NUMBER: 23-027-03

Instrument Panel Rattle Sound

This bulletin involves modifying the IP center defroster duct.

2003 - 2004 (ZB) Viper

Fig. 1 MODIFY DEFROSTER DUCT

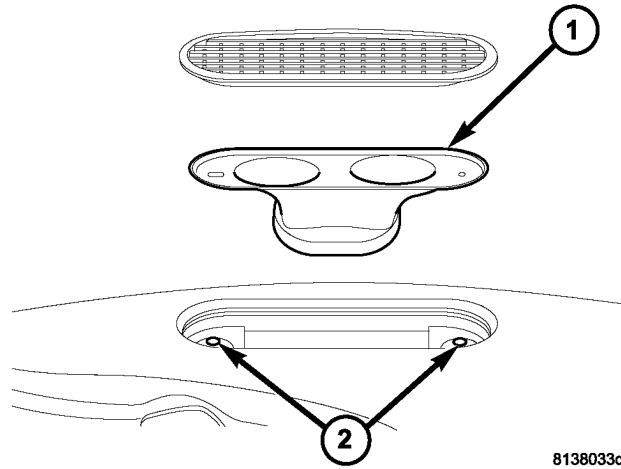
Rattle sound from IP defroster grille area may be heard when driving over rough road surfaces. The defroster duct flange is touching bottom of defrost grille and/or IP substrate.

1. Remove the defroster grille from IP (using trim stick or equivalent).
2. Remove the defroster duct mounting screws (2) and defroster duct (Fig. 1).
3. Using snips/cutters, remove upstanding flange around entire outlet side of duct (Fig. 1).

- 1 - REMOVE THE UPSTANDING FLANGE
- 2 - DUCT RETAINING SCREWS

- 4. Remove any loose debris from the defroster duct area.
- 5. Reinstall duct with two screws, tighten the screws to 1.6 - 2.2 Nm (14 - 20 in. lbs.).
- 6. Reinstall defroster grille making sure it is secure around entire outside edge.
